Riley Purgatory Bluff Creek Watershed District Permit Application Review

Permit No: 2016-017 – modification

Applicant: Metropolitan Council – Southwest Light Rail Transit (SWLRT) Project

Project: SWLRT - Construction of approximately 1.5 miles of SWLRT project corridor including light rail construction, road reconstruction, and construction of the Southwest Light Rail Transit Station area and bridge was approved in early 2017. Stormwater management facilities including one wet pond, seven infiltration basins, 19 ditches with check dams, pervious pavement, and planter boxes were constructed to provide volume control, water quality, and rate control for runoff prior to discharging offsite. Metropolitan Council has requested approval of a modification to the plans for the project involving conversion of the pervious pavement to combination of granite rock and impervious surface at three Traction Power Substation (TPSS) locations.

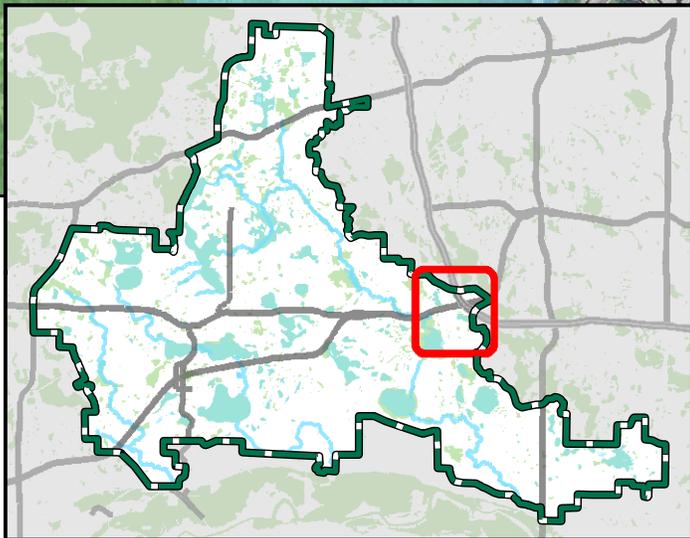
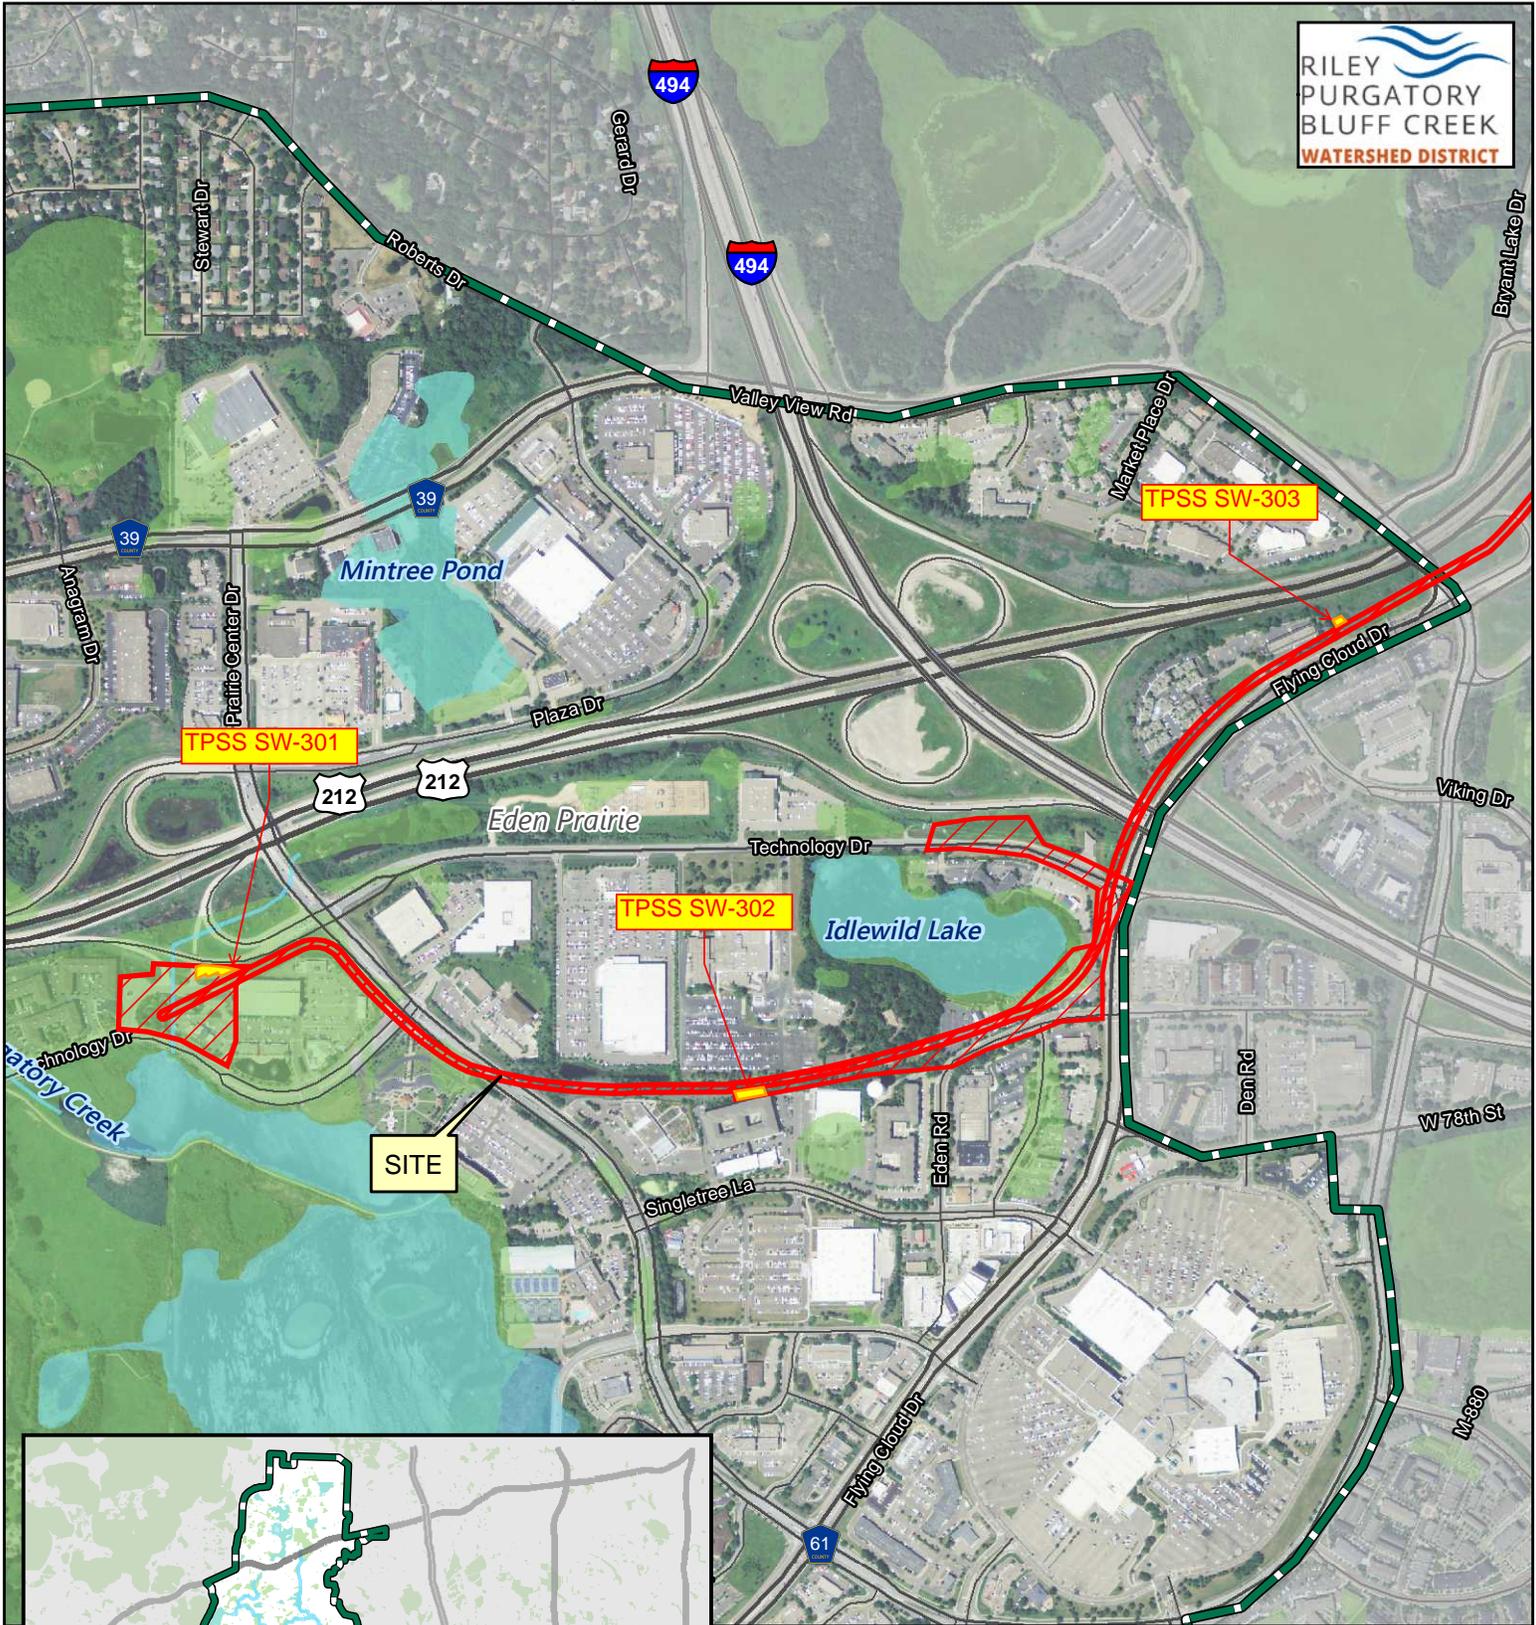
Most of the work is complete at the TPSS locations except for the proposed 1.5-inch granite aggregate and impervious pads (see adjacent photo of current site condition at TPSS 302 showing the approved course filter aggregate). Of the 17,769 square feet (SF) associated with the TPSS locations, 8,322 SF was approved impervious surface under permit 2016-017, 840 SF will be new additional bituminous, and the remaining portion of the TPSS locations will be covered with 1.5-inch granite aggregate above the approved course filter aggregate and fine filter aggregate with elevated drain tile to promote abstraction. While overall site and project is provided for context, the analysis below is limited to the stormwater management rule criteria impacted by the proposed modification (rate, volume, and water quality). The applicant has completed design and is proposing a modification to permit 2016-017 to document the continued compliance.

3 WALKING BALLAST
TYPICAL SECTION
NOT TO SCALE

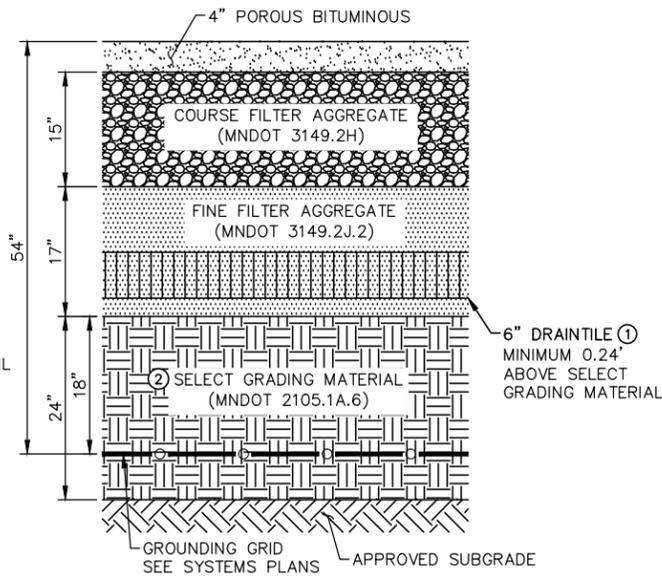
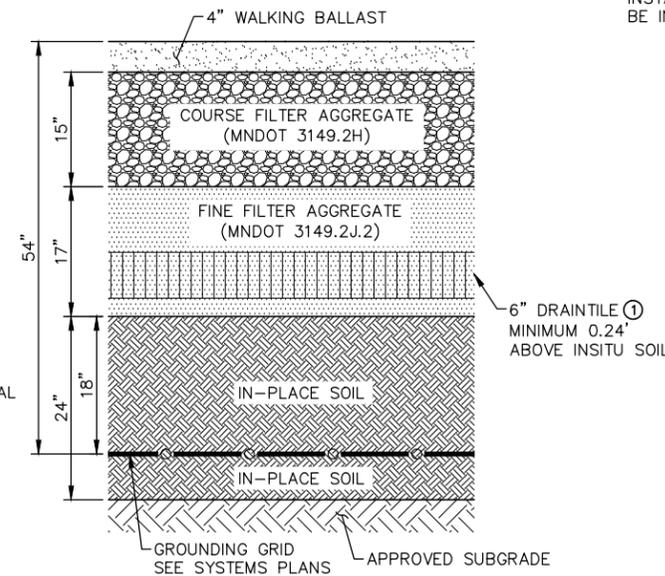
Subsections 3.1.b and 2.3 of Rule J require the abstraction onsite of 1.1 inches of runoff from all impervious surfaces at the TPSS redevelopment locations. The Applicant proposes to install 1.5-inch granite aggregate over course filter aggregate and fine filter aggregate with elevated draitile to cover most of the TPSS sites to mitigate the need to provide additional rate control, volume abstraction, and water quality treatment. The following table summarizes land cover types associated with the TPSS locations.

Because the fine filter aggregate below the draitile will provide abstraction for 1.1 inches of runoff from the constructed buildings and the impervious surface added to the project with this requested modification. The engineer concurs with the applicant’s design infiltration rateand that the fine filter aggregate below the drwiantile will draw down within 48 hours (Rule J, subsection 3.1b.3)
